REQUEST FOR CERTIFICATE OF APPROPRIATENESS

Petitioner: Bill Glass

MPC File No.: 26-002750-COA

Address: 410 West 40th Street

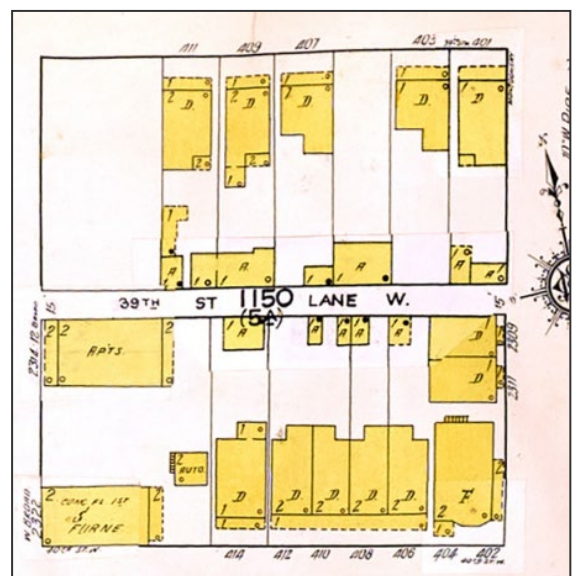
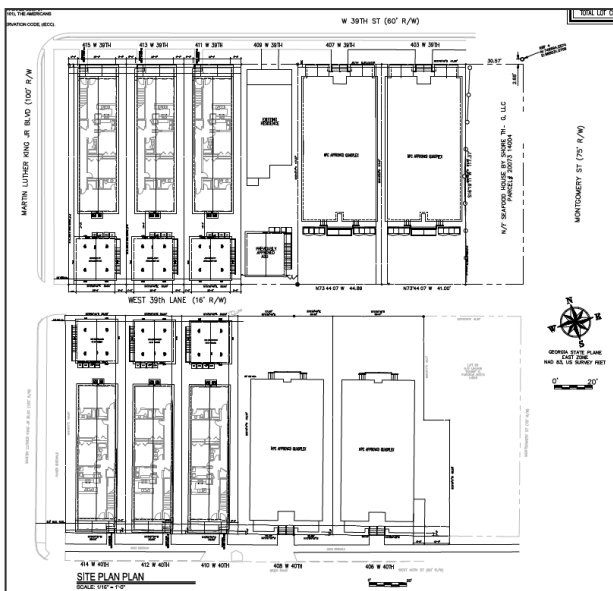
The proposed streetscape below shows the three two-story duplexes in a row similar to the Sanborn Map, bringing a sense of rhythm back to the mostly empty side of the street. As noted with the same project on West 39th Street, this is part of a larger effort to revitalize the MLK Corridor and is within an enterprise zone aiming to bring commercial and residential developments and rehabilitation back to this area.

The site plan below shows the overall proposed and some previously approved new construction to be seen on both West 39th and West 40th Streets. For comparison, the 1953 Sanborn map of both streets showing the earlier development pattern that has largely been lost.
